Permitting the authorities of the ^aTaylor high school, Narasapur,
to use built up girders instead of rolled steel girders in the con-
struction of the ---- for science laboratory.

Submitting to Government letter No.323 dated 10-3-18 from the Correspondent, Taylor High school, Narsapur, regarding construction of science laboratory.

Built-up Girders.

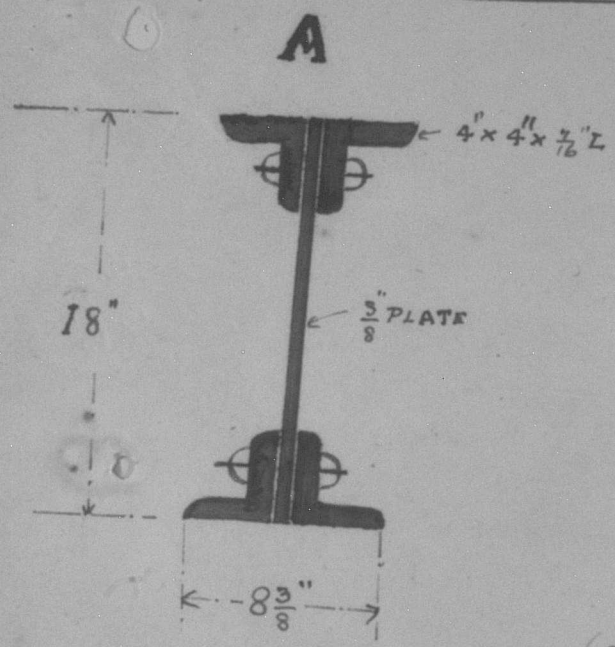
Sketch "A" shews a girder 18" x 8 $\frac{3}{8}$ ", weight approximately 70 lbs. per foot. Of this we can make up 5 @ 890/- each.

Sketch B shews a girder 16 $\frac{1}{2}$ " x 7", approximate weight 75 lbs. per foot, to which we can make up the other 4 for Rs. 990/- each.

As the plates are not all 27' long we should have to join some of the girders, and we should be glad if you would let us know at what points the upper Beams, if such are being used, cross the main beams, in order that we may decide to the best positions for joints.

The file may be forwarded to P.W.D. no.
with reference to that department's note on
page 9 of G.O. No. 341 Ed. dt. the 15.3.18 for
remarks whether the authorities of the school
may be permitted to use five guiders of
Sketch A and four of Sketch B.

The pieces shown in Sketch B
may also be used
